**BASE SUPPORT BUILDING (SWMU 014) PLUMESTOP® INJECTION  
PILOT STUDY WORK PLAN  
KENNEDY SPACE CENTER, FLORIDA**

**December 2023  
Revision: 0**

**Subject:** Response to Comments on PFAS Site Assessment and Mitigation – PlumeStop® Injection Pilot Study Work Plan Base Support Building (Formerly Maintenance & Operations Building) ADP

## Design Summary

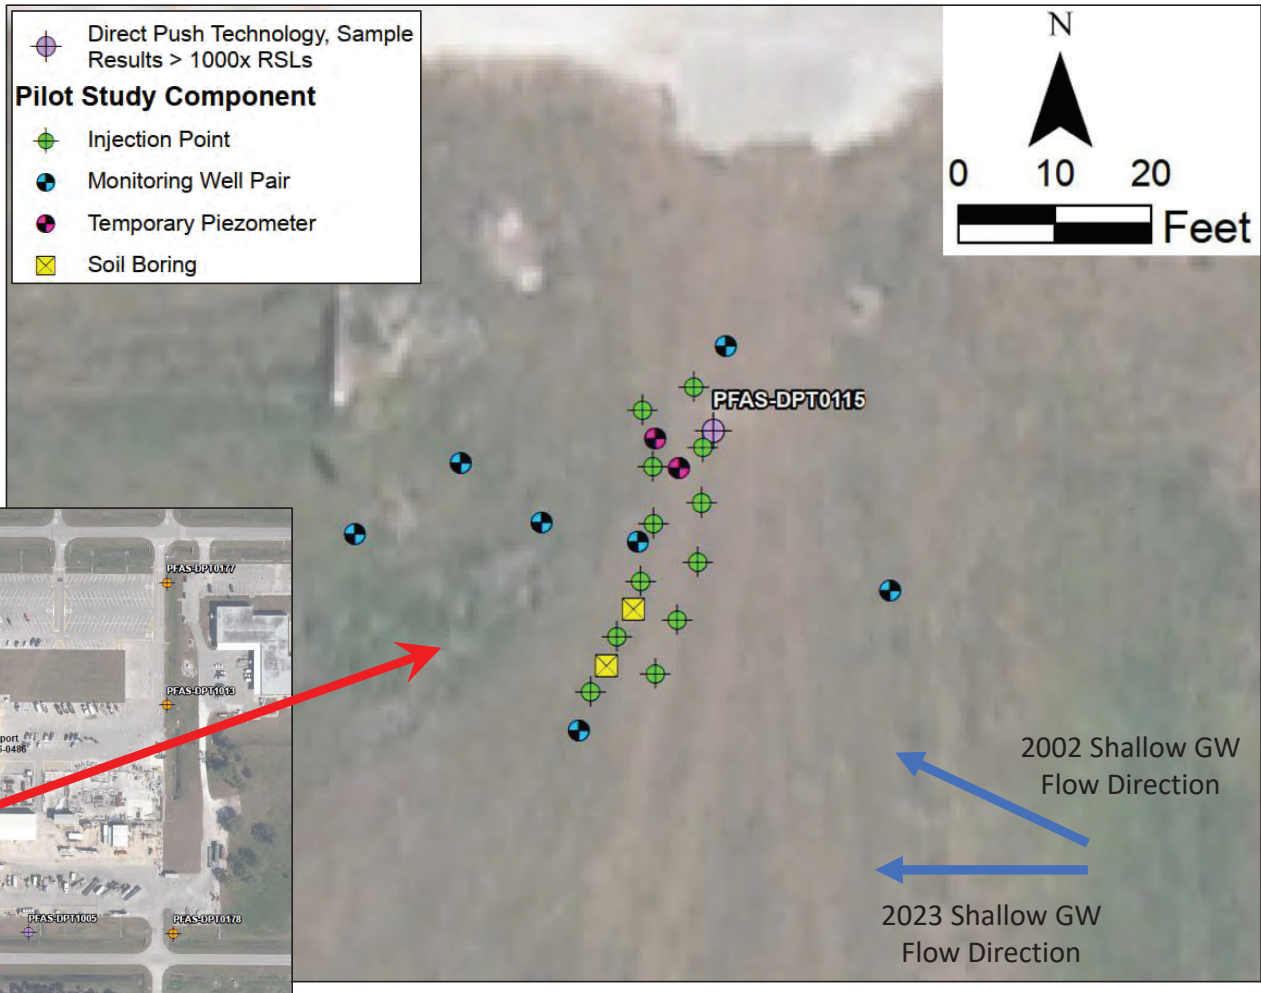
- HGL Comment #3: Slide 14. Seepage velocity is 82.5 ft/yr based on hydraulic conductivity of 20 ft/day (7300 ft/yr x .0026 ft/ft)/.23 = 82.5 ft/yr. High seepage velocity (82.5 ft/yr, or 41 ft/yr as in ADP) plus quartz sand aquifer means it is possible that the PlumeStop will be actively transported rather than acting as a “fixed” barrier. Please address that possibility.

- Tetra Tech Comment #2: Slide 14 – Spacing within rows (5 feet) is listed on the design summary. Specify the spacing between the two rows and the basis for the estimated radius of influence for each injection

- Tetra Tech Comment #3: Slide 14 – Please provide the basis for the PlumeStop dosage of 367 lbs per injection point.
- *Response: The dosage was recommended by Regenesis as a typical value based on their application experience.*

- *Response: This question was posed to Regenesis, the supplier of PlumeStop. Their reply is as follows:*  
*“For the proposed KSC pilot the 7 cm/day (83 ft/yr) seepage would normally not be a concern. A sediment sieve-analysis is useful in predicting any unwanted advection. With the pre-emptive application of a divalent cation solution (i.e. calcium chloride) the carbon set-up can be accelerated to 'park' the PlumeStop in the intended target treatment zone.” Grain size analyses will be performed prior to injection of the PlumeStop. If excessive advection is suspected as a result of these grain size analyses, the application of a calcium chloride solution will be considered.*

- *Response: The spacing between the rows is approximately 5 feet. The radius of influence was recommended by Regenesis as a commonly observed value based on their application experience.*

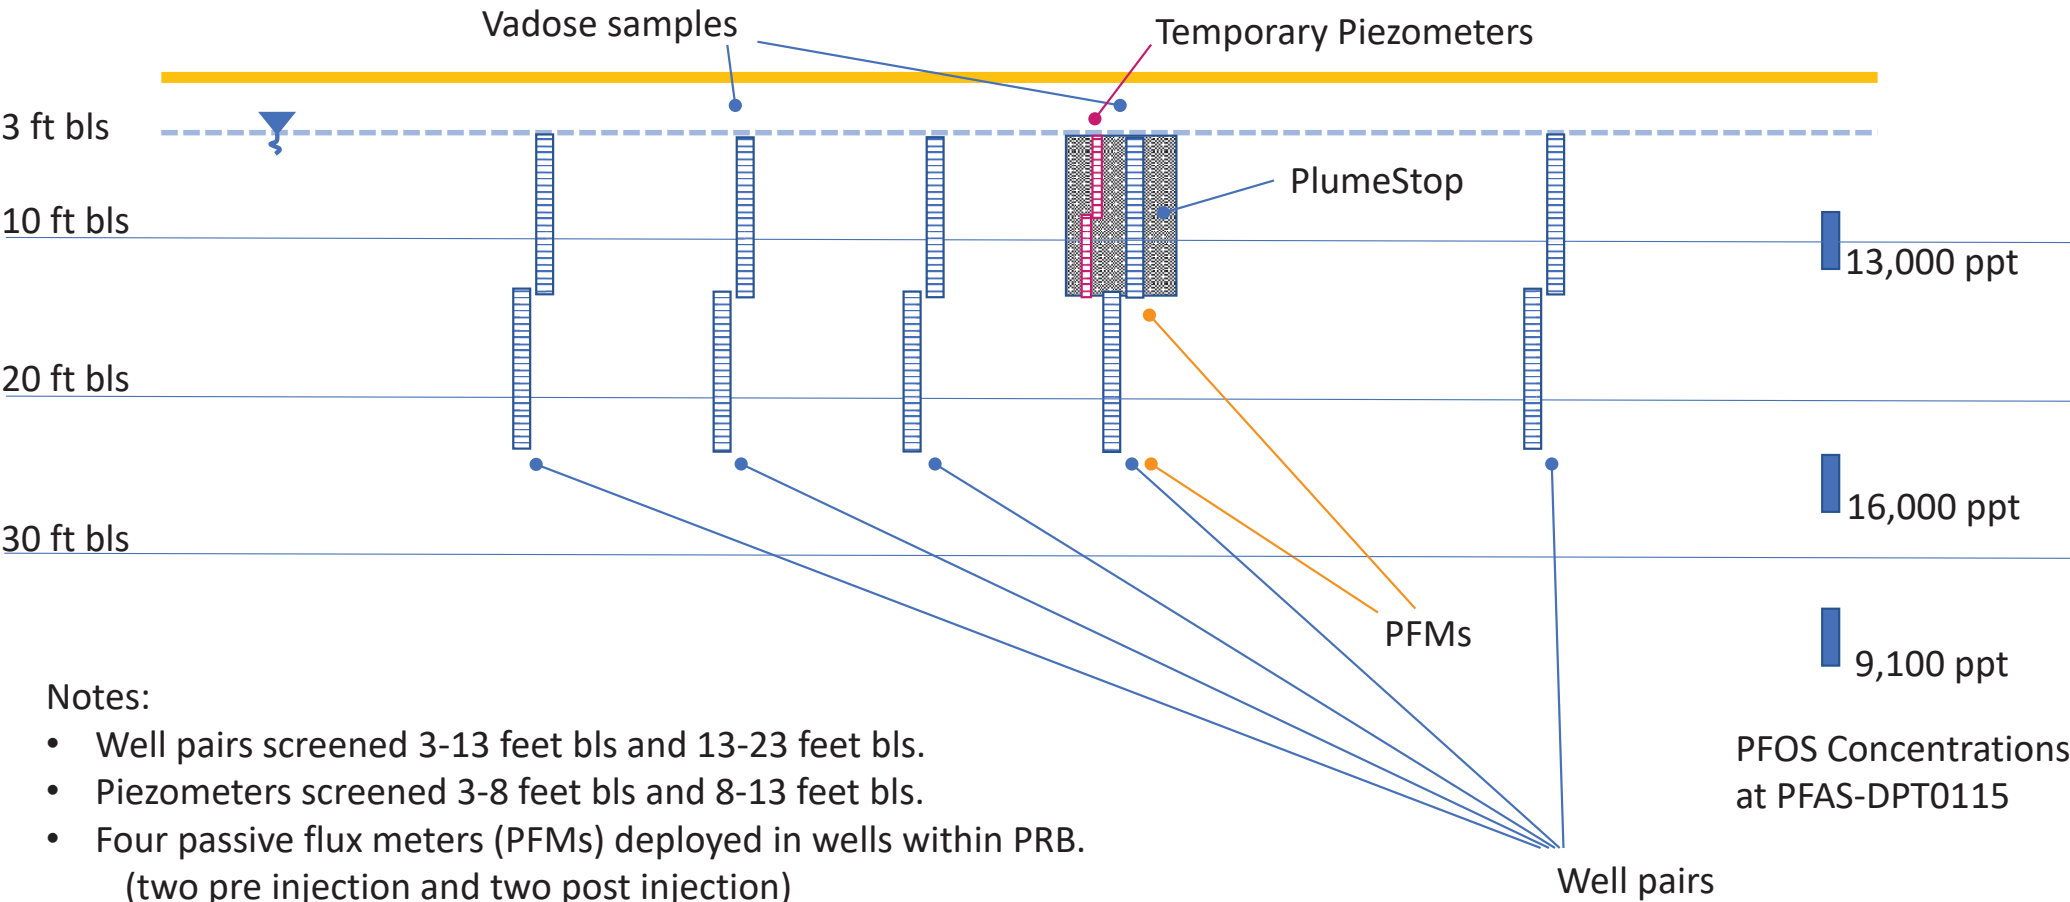
- Tetra Tech Comment #4: Slide 14 – With the shape of the 1,000x RSL plume indicating a prevailing flow almost directly northwest, considering orienting the upgradient and downgradient monitoring well pairs more in that direction, or adding one more upgradient well pair southwest of the well currently shown.
- *Response: As indicated on Slide 13, the flow direction can vary between west and northwest. The orientation of the barrier was aligned as an approximate average of the two directions. Additional existing monitoring wells may be gauged during implementation to develop a more comprehensive picture of the shallow potentiometric surface.*

- HGL Comment #4: Slides 14 and 15: The plan view on page 14 shows two soil boring locations within the downgradient injection line, but the cross-section on page 15 shows one soil sample location within the PRB alignment and the second one downgradient of the PRB. Please resolve this apparent inconsistency between the two slides.
- *Response: The yellow soil borings are to be deployed during the Placement Validation activities, described on Slide 22. The 50 foot soil core will be collected during installation of the monitoring well within the barrier alignment. Vadose zone soil samples will be collected during installation of monitoring wells within, and downgradient of the PRB.*

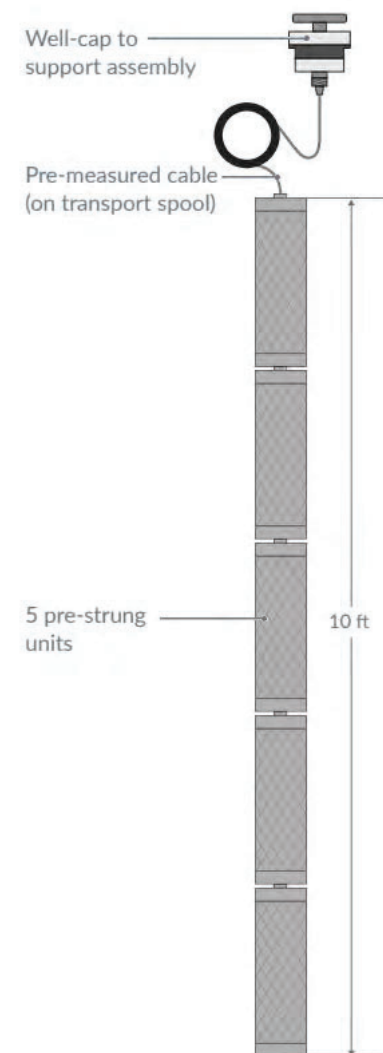
- HGL Comment #5: Slide 17: Instead of specifying depths for the two TOC samples, suggest selecting the TOC sample interval to target different lithologies based on field observations. For example, 8 ft bgs and 18 ft bgs at SO14-LB01 and SO14-LB02 (Slide 11) would sample the same lithologic type (SP of SO14-LB01 and SW for SO14-LB02). For future designs, it would be helpful to obtain TOC data for the range of lithologies likely to be encountered.

- *Response: Text will be amended to read "...at 8 feet and 18 feet, or within different soil types, based on field observations."*
- Tetra Tech Comment #5: Slide 17 – Slide states soil samples will be collected "within and downgradient of PRB area". However, figure on slide 14 shows both locations within PRB area. Please reconcile.

- *Response: The yellow borings indicated on Slide 17 will be advanced during the Placement Validation phase on Slide 22. The vadose zone soil samples will be collected during installation of monitoring wells.*

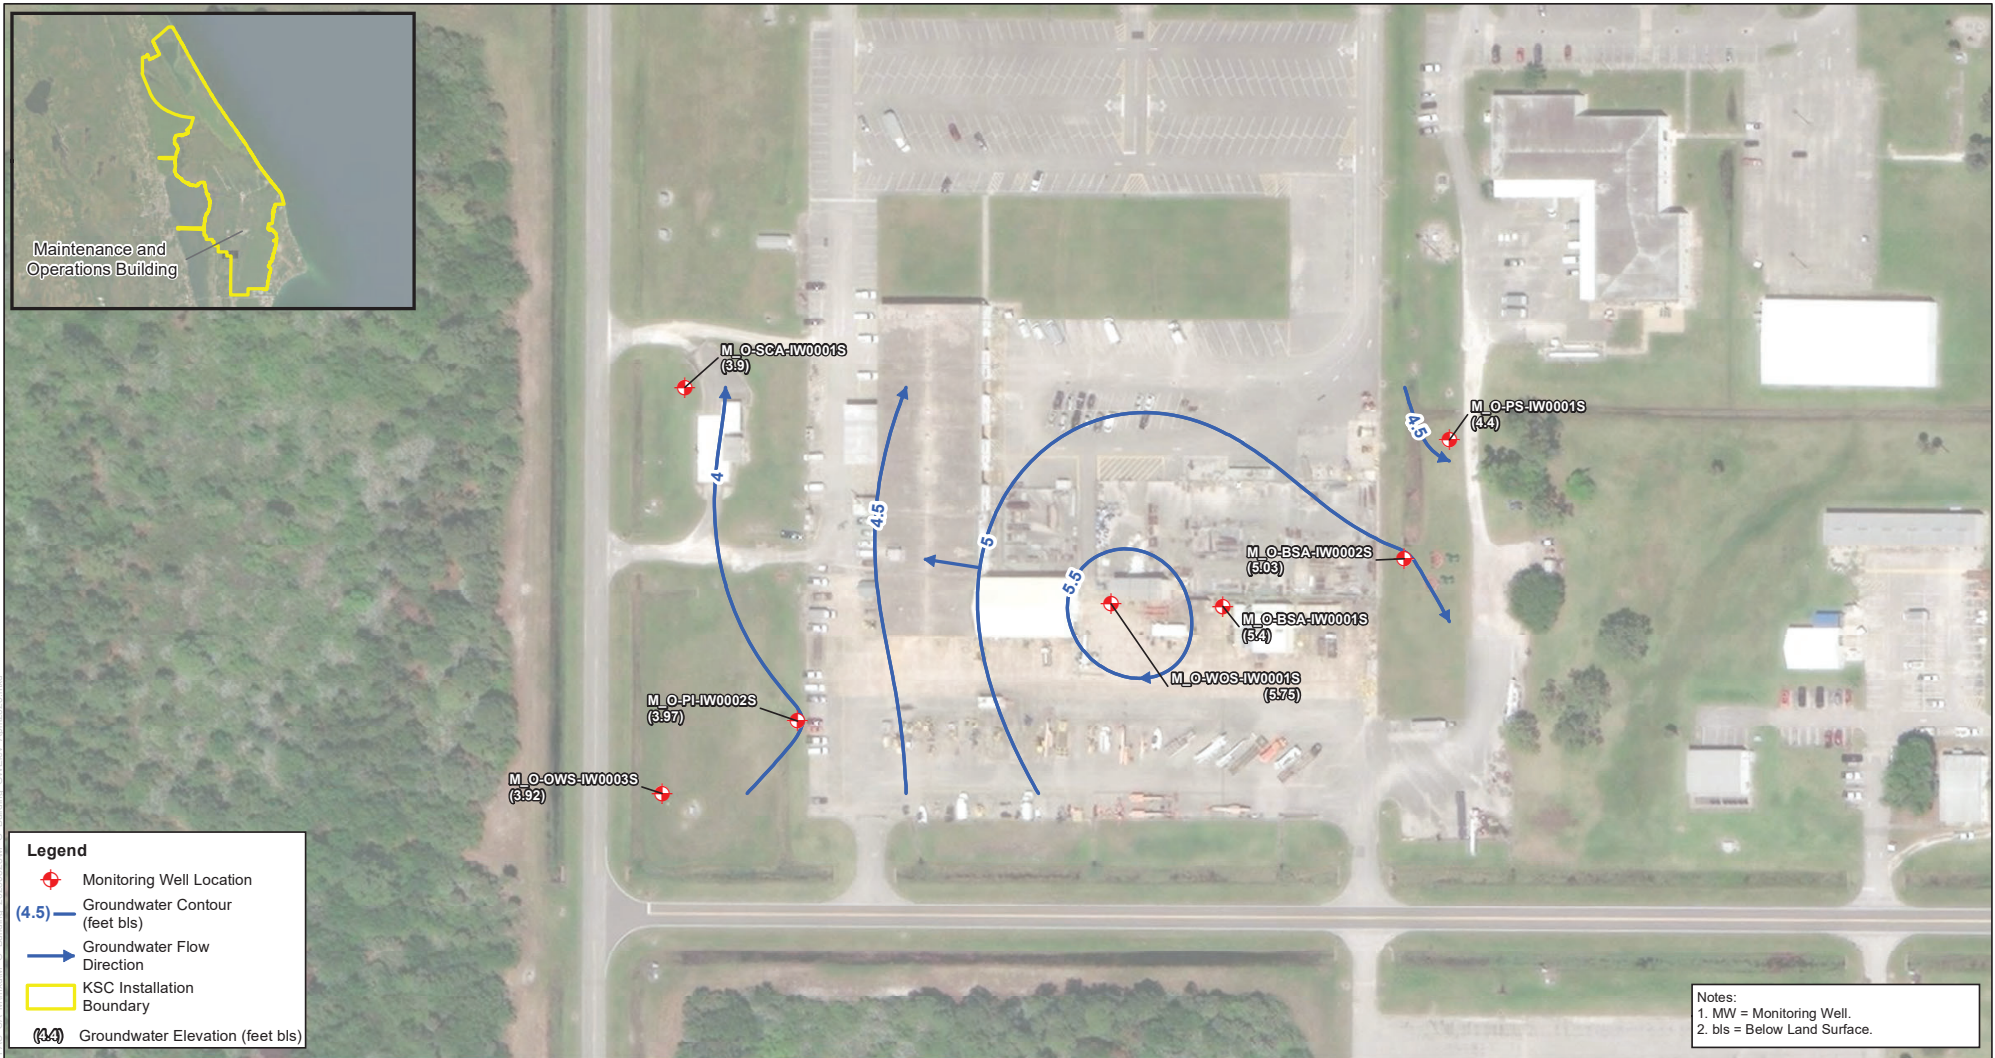
- Tetra Tech Comment #6: Slide 24 – Consider collecting soil/PlumeStop samples from the PRB area during select performance monitoring events to confirm the PRB is still intact.  
– *Response: This activity will be considered.*
- Tetra Tech Comment #7: Slide 24 – Consider collecting soil/PlumeStop samples from within the PRB at the conclusion of the study to estimate PFAS capture.  
– *Response: This activity will be considered.*
- Tetra Tech Comment #8: Slide 24 – Consider using pressure transducers in select wells and nearby surface water to provide a more thorough analysis of groundwater flow horizontally and vertically (and groundwater-surface water interaction) over time and in response to precipitation events. This may provide valuable data for a full-scale design (wall placement, depth, etc.).  
– *Response: This activity will be considered.*
